Re: FCC ID OV5-VCA10001
Applicant: John Deere Special Technologies
Correspondence Reference Number: 13156
731 Confirmation Number: EA96765
Date of Original E-Mail: 03/30/2000

DATE: 12-Apr-00
TO: Joel Schneider
CC: Ron Stahlhut, William Coopman
FROM: Bill Crook
SUBJECT: Bell 212A Modem Occupied Bandwidth Measurement

CVDM-2000 - Bell 212A, 1200 Baud, DPSK MODEM (NJ1CV0M-2000)

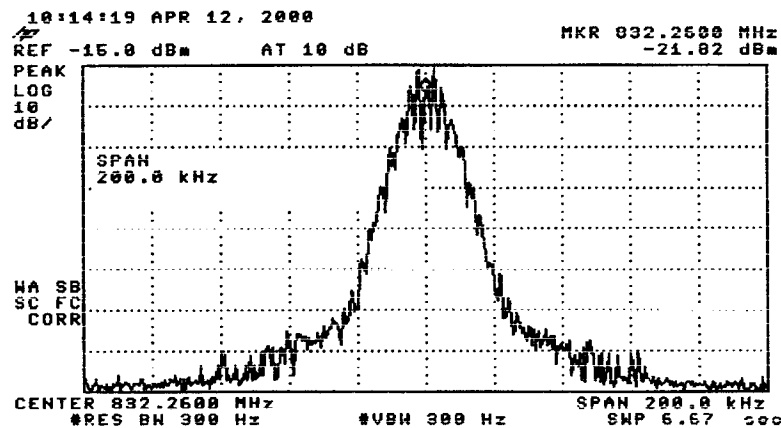
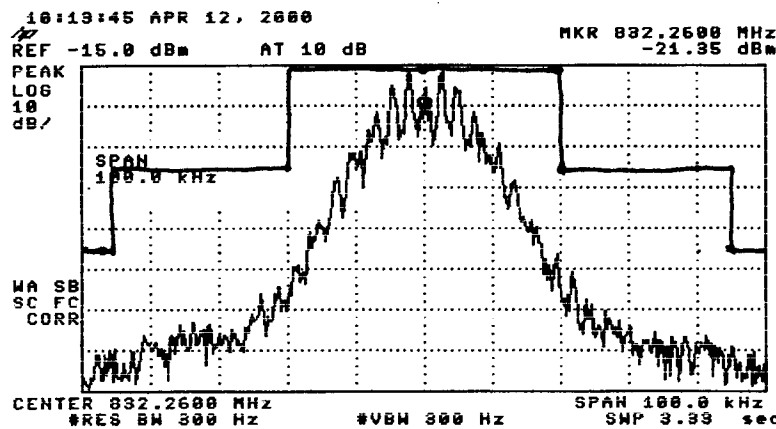
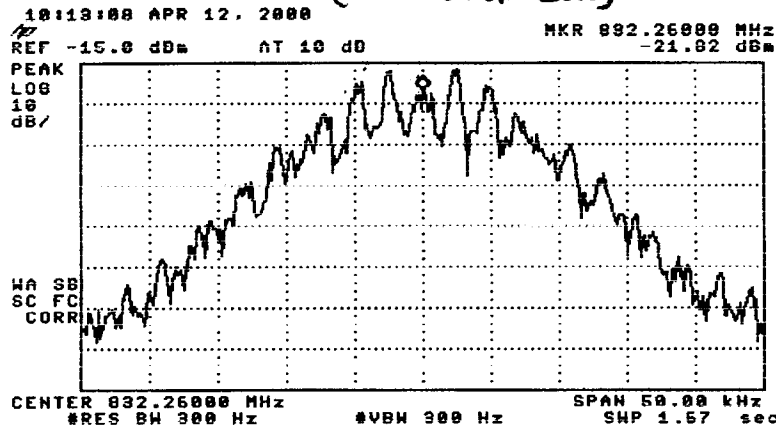
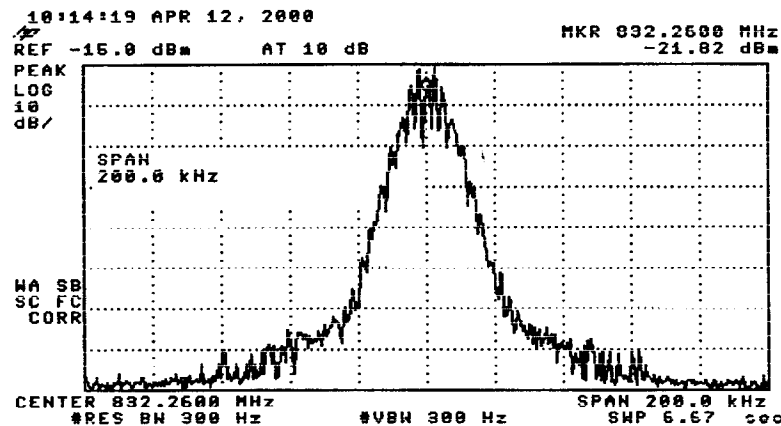
The grant can only reflect the actual capability of the device. The voice specification will be deleted. The specification 40K0F1D must be justified or corrected.
40K0F1D represents a signal with a necessary bandwidth of 40 khz , FM modulation and data.
You need to supply the necessary bandwidth calculation (2M+2D) for the 1200 baud signal. Where M is the maximum modulation frequency and D is the maximum deviation. This should be consistent with the plot of the emission.
The emission designator must be corrected accordingly.

You also requested a Carson's Rule estimation of the occupied bandwidth. The modulation frequency is 1.2 kHz and the peak deviation is about 2.5 kHz. Therefore, the estimated bandwidth is $2(1.2 + 2.5) = 7.4$ kHz.

Susan, please change the emission designator to 7k4f1d. Attach occupied bw measurements from Bill Crook, along with graphs, and paper graph with emission mask drawn on it. Include new pictures of test setups from W0208. Include data sheets for W0208 Run 3.
